MICHIGAN DEPARTMENT OF STATE HIGHWAYS
 CLARENDON AVE. PEDESTRIAN BRIDGE
 OVER THE JEFFRIES FREEWAY IN DETROIT

GENERAL PLAN OF SITE

**PRELIMINARY PLAN "A" DATED APRIL 29, 1968
 BID LETTING DATE APRIL 13, 1969**

ELEVATION
Scale: 3/32" = 1'-0"

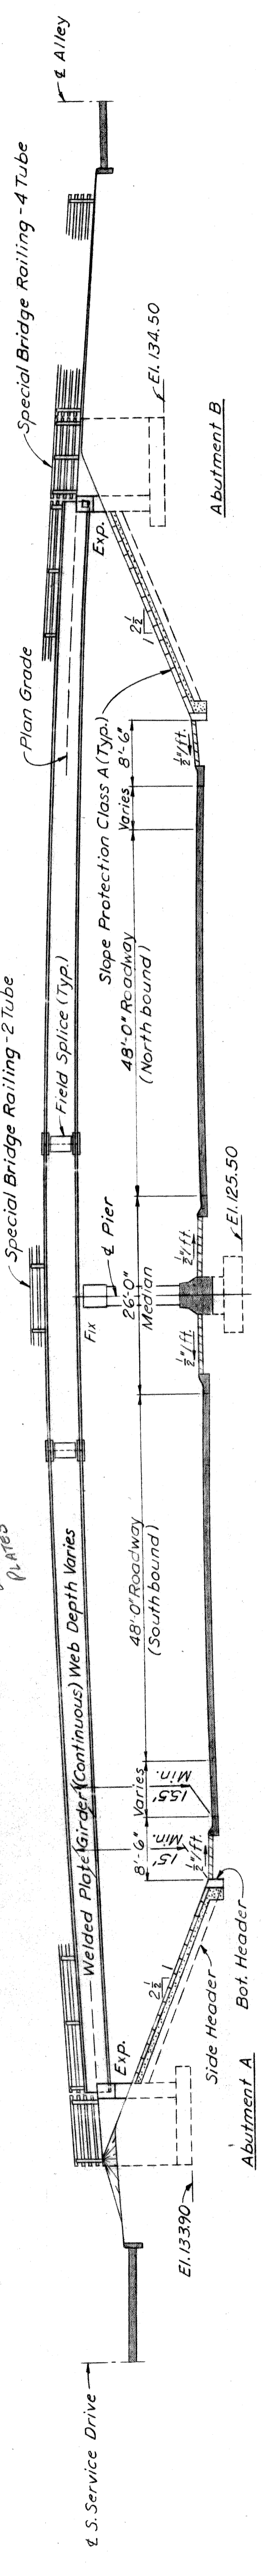
USE A ROLLED BEAM, WITH TOP AND BOTTOM MOMENT CURVE PLATES IN NEG. 1/2 POS. MOMENT AREAS IF NECESSARY

GENERAL PLAN OF STRUCTURE

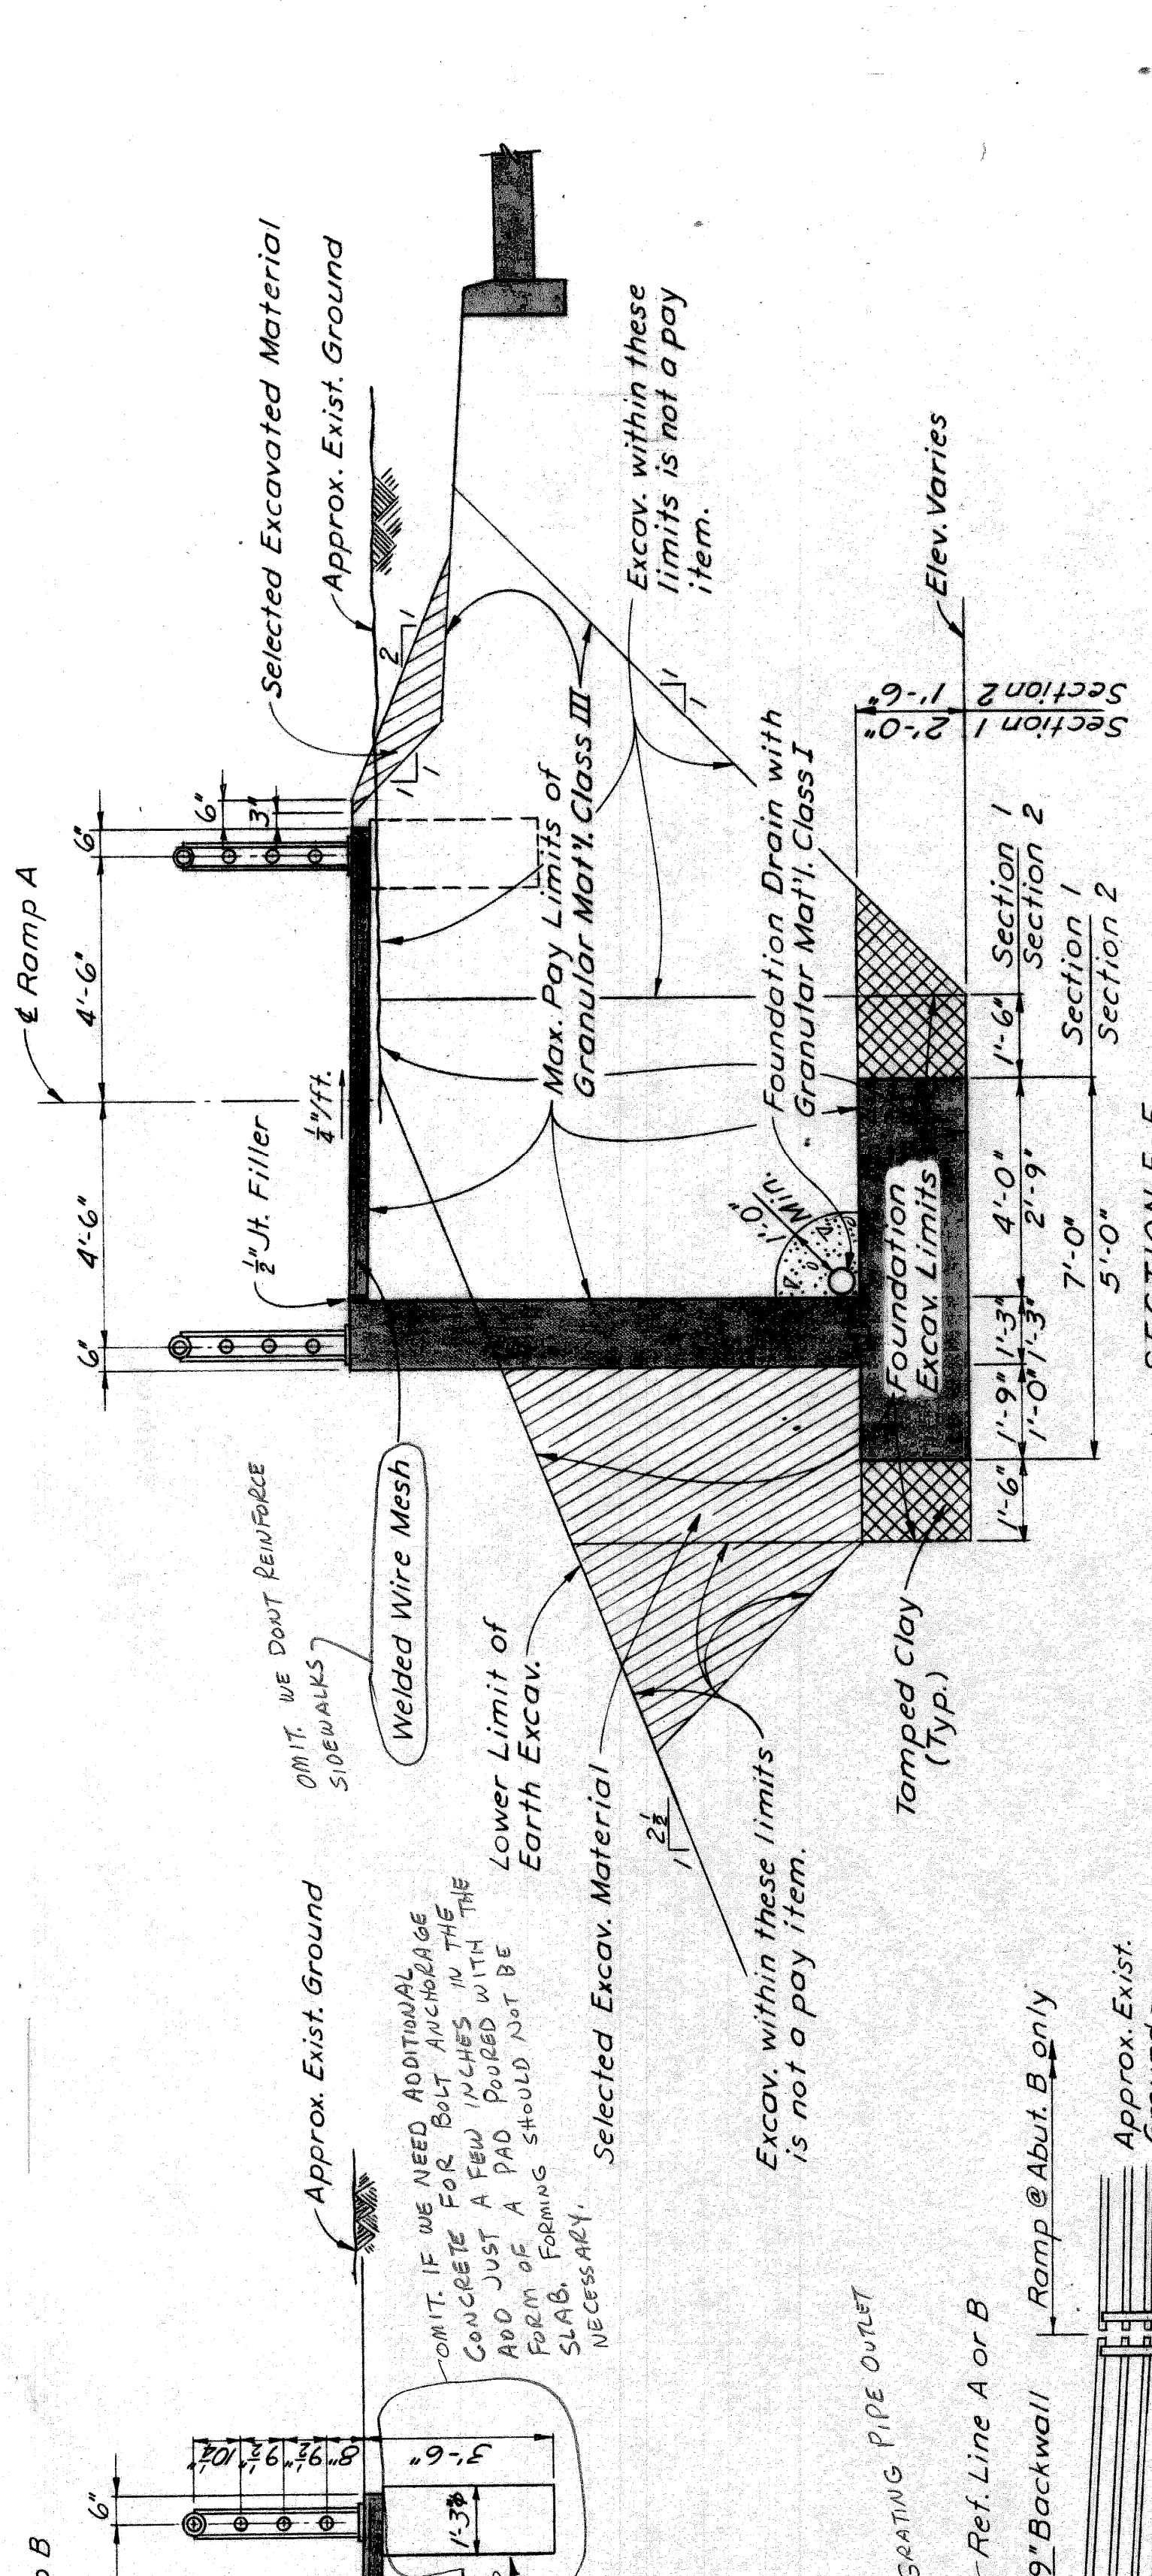
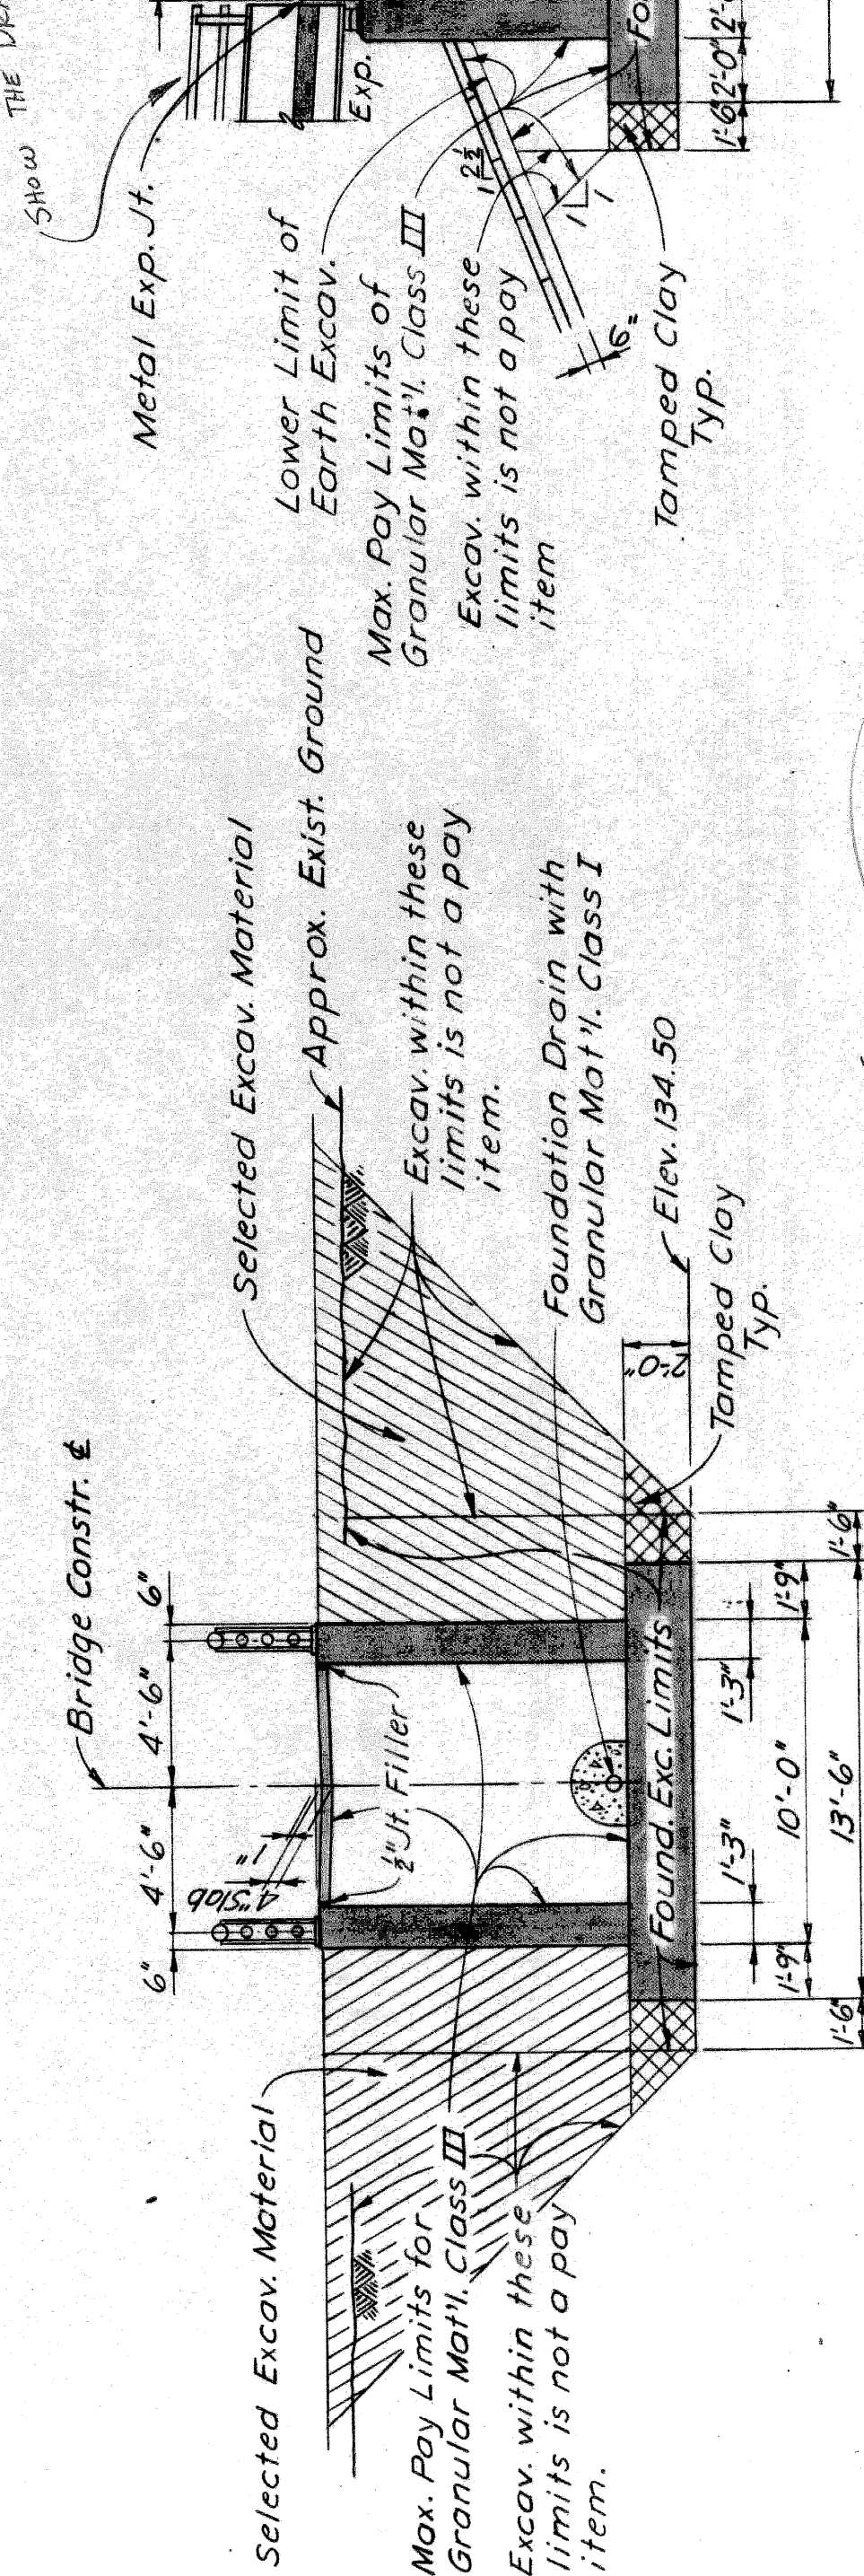
Pressures Applied to be 700 lb/sq. ft. we will advise next week
